**Re: Response Letter – Transportation Study Addendum
117 Forest Avenue and 175 Catharine Street South
City of Hamilton
Our Project No. NT-16-103**

SUBJECT: 117 Forest Avenue and 175 Catharine Street South, Hamilton (Ward 2)
ZAC-23-019

Figure 1 – Short-Term and Long-Term Bicycle Parking Spaces

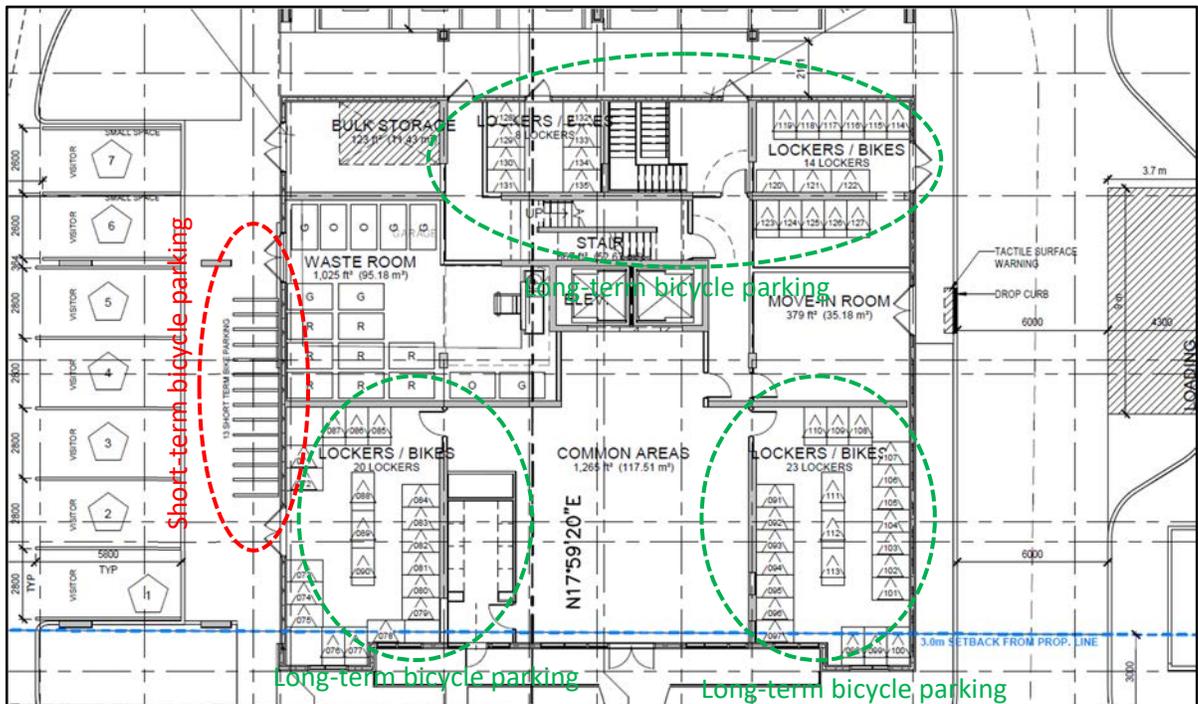
- Transportation Planning requires short-term and long-term bicycle parking to be provided as per the requirements of the City of Hamilton Comprehensive Zoning By-law 05-200, Section 5: Parking. All short-term and long-term bicycle parking shall be clearly indicated, illustrated and the total number of spaces shall be numbered on the site plan accordingly.

Response: Noted. This comment has been addressed in Table 1 below. All short-term and long-term bicycle parking spaces are indicated on the site plan, as illustrated in Figure 1 and Appendix B.

Based on the current Zoning By-law requirement, the proposed development requires 129 bicycle parking spaces (5 short-term and 124 long-term). The proposed development will provide a total of 124 long-term and 5 short-term spaces, for a total of 129 bicycle parking spaces. This meets the Zoning By-law requirement and this provision will encourage future residents to use active mode of transportation to and from the proposed development.

Figure 2 – Catharine Street South and Forest Avenue Daylight Triangle

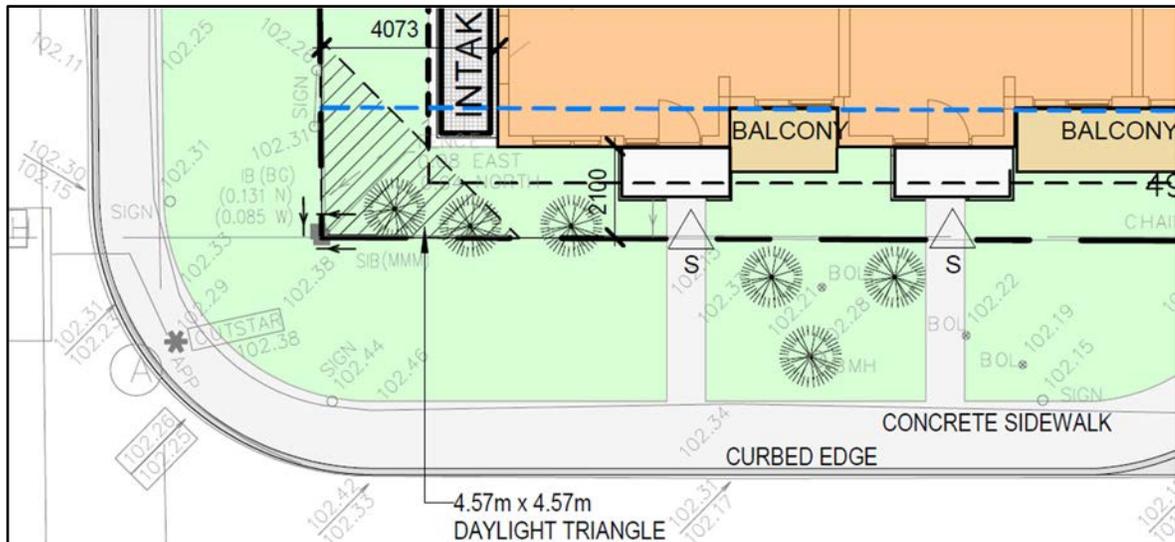
7. Catharine Street South & Forest Avenue are both Local Roads. The Applicant is to dedicate a 4.57 metres x 4.57 metres Daylighting Triangle to the right-of-way, as per the Council Approved Urban Official Plan: Chapter C - City Wide Systems and Designations 4.5 Road Network Functional Classification; Daylighting Triangles 4.5.7.

Response: This comment has been addressed in the revised site plan (Appendix B), as per **Figure 2**.

Figure 3 – Catharine Street South and Young Street

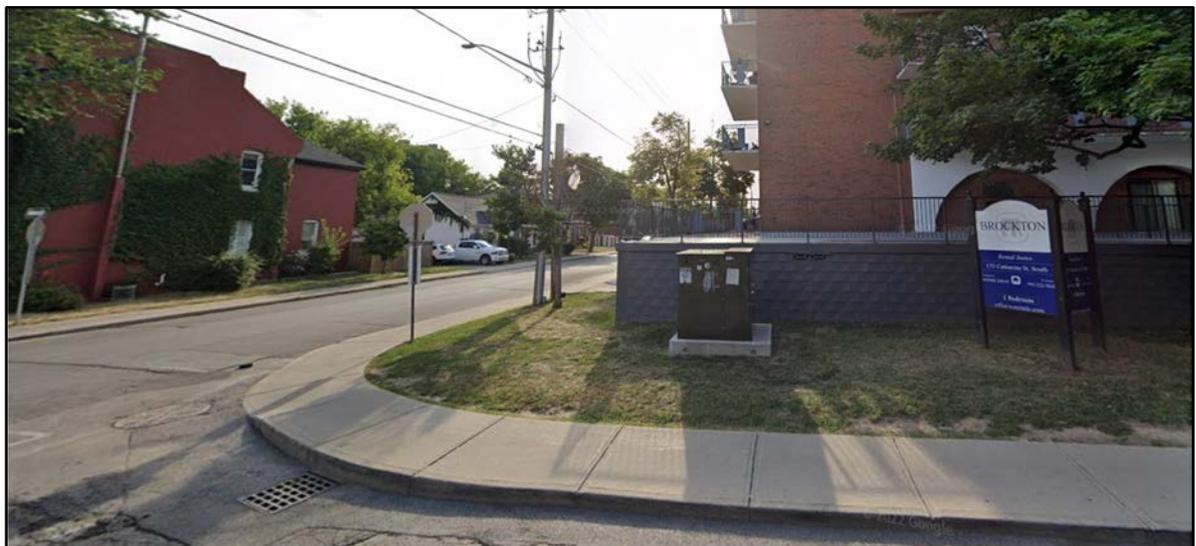
8. Catharine Street South & Young Street are both Local Roads. The Applicant is to dedicate a 4.57 metres x 4.57 metres Daylighting Triangle to the right-of-way, as per the Council Approved Urban Official Plan: Chapter C - City Wide Systems and Designations 4.5 Road Network Functional Classification; Daylighting Triangles 4.5.7.

Response: It should be noted that this requirement is not possible as both the existing transformer and building bearing wall will remain and will not be altered as part of the site redevelopment. Please see **Figure 3** for more information. Therefore, the required daylight triangle cannot be provided and it will be operating similar to the existing condition.

Figure 4 – Daylight Triangle Requirements for Proposed Driveways

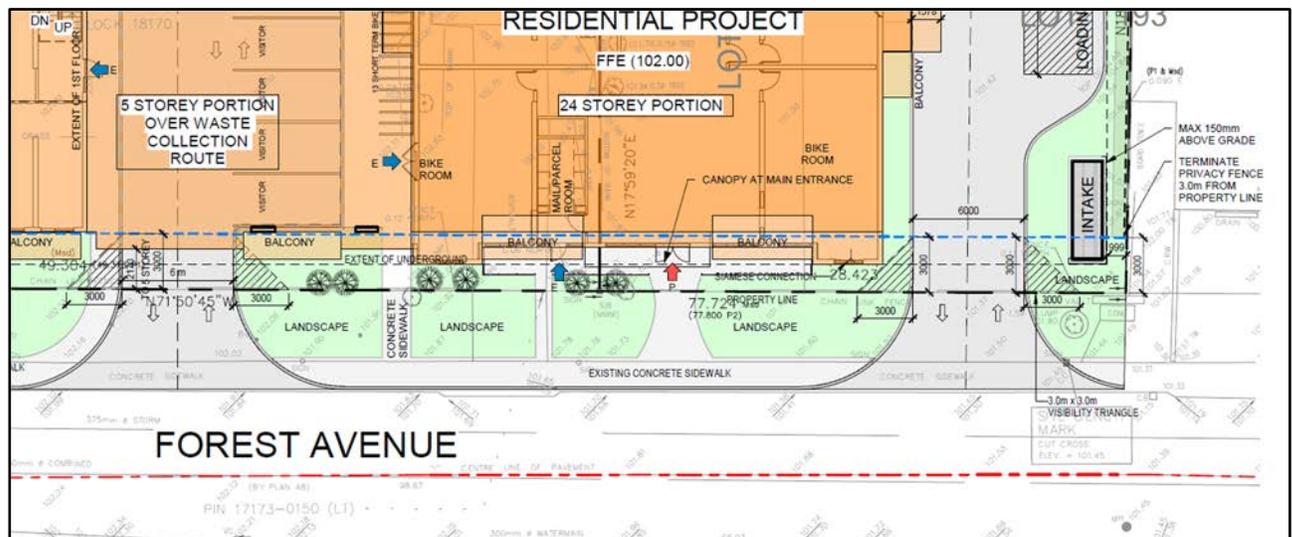
12. A minimum of 3.0 metres x 3.0 metres visibility triangles should be provided for each driveway access. They must be illustrated, dimensioned and identified on the site plan. Visibility triangles are between the driveway limits and the ultimate property line (right-of-way limit) and no object or mature vegetation can exceed a height of 0.6 metres above the corresponding perpendicular centreline elevation of the adjacent street.

Notwithstanding and without setting precedent, Transportation Planning will accept reduced visibility triangle dimensions however the Applicant shall consider visibility restrictions when designing the at-grade features of the subject lands in the areas where a typical 3.0 metre x 3.0 metre visibility triangle would be located, as illustrated in Figure 2.

Response: Noted. This requirement has been addressed in the revised site plan (Appendix B) and Figure 4 below.

Figure 5 – Convex Mirrors and Warning Signage

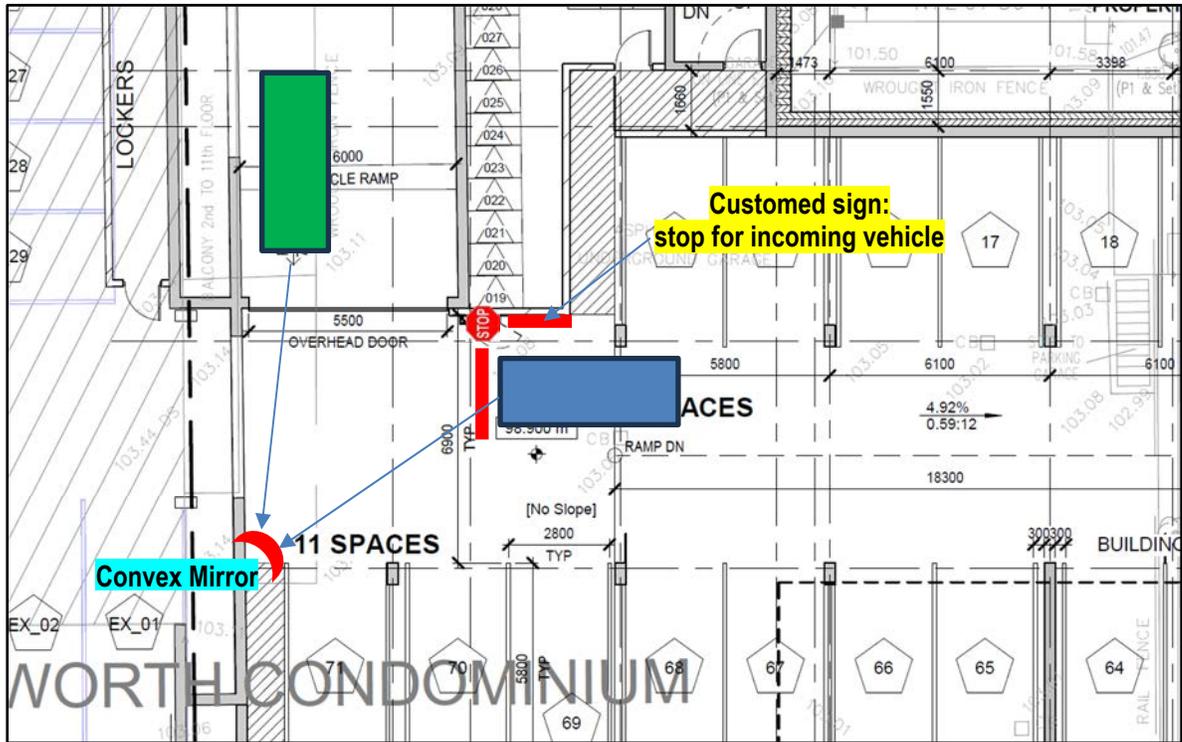
Transportation Planning recommends mirrors or warning systems to be implemented within this area to assist in facilitating the two-way movement of vehicles entering/exiting the underground parking area.

Figure 2: Subject Submission Overhead Door Width

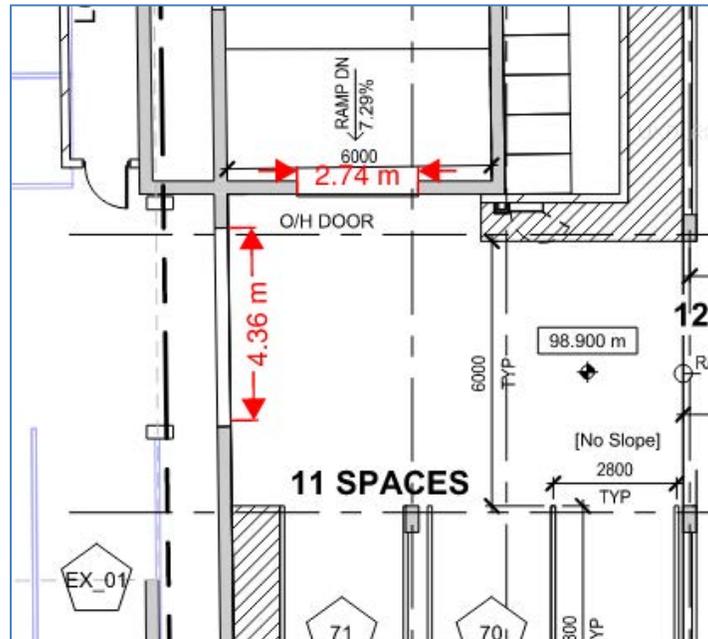
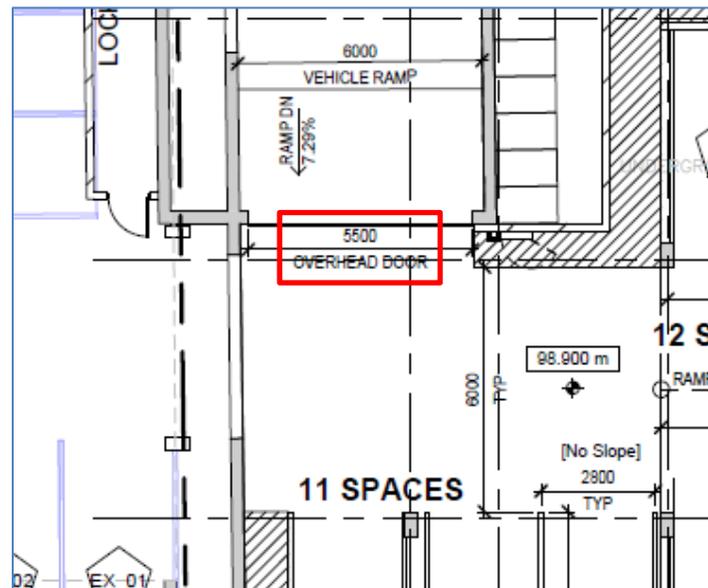
- 11. The proposed 'Covered Ramp to Underground Concrete Terrace' is too narrow to allow for two-way movements based on approximate dimensions measured from the most recent site plan submitted as illustrated in **Figure 2**.

Transportation Planning indicates that interim discussions between the Applicant and City staff have noted a discrepancy in the overhead door width. A corrected interim submission site plan illustrated in **Figure 3** indicates the overhead door width shall be 5.5 metres. Typically, a minimum of 6.0 metres is required to facilitate two-way movements internal to private property. Notwithstanding and without setting precedent, Transportation Planning will accept the proposed overhead door width of 5.5 metres, as the overall number of parking stalls is low and there is a long approach throat length extending from Young Street that will allow for vehicles to queue while waiting for opposing vehicles to maneuver in/out of the underground parking area.

Transportation Planning recommends mirrors or warning systems to be implemented within this area to assist in facilitating the two-way movement of vehicles entering/exiting the underground parking area.

Response: The proposed site plan has been revised to provide a general 6m width underground vehicle ramp width that connects to Young Street. The narrowest part will be the overhead door with 5.5m width (at the bottom of the ramp). However, given that the inbound and outbound vehicle will be slowing down or stop at this location, this width should be sufficient for two-way movement. The City has indicated that this is acceptable in Comment #11 below. The revised site plan is included in **Appendix B**.
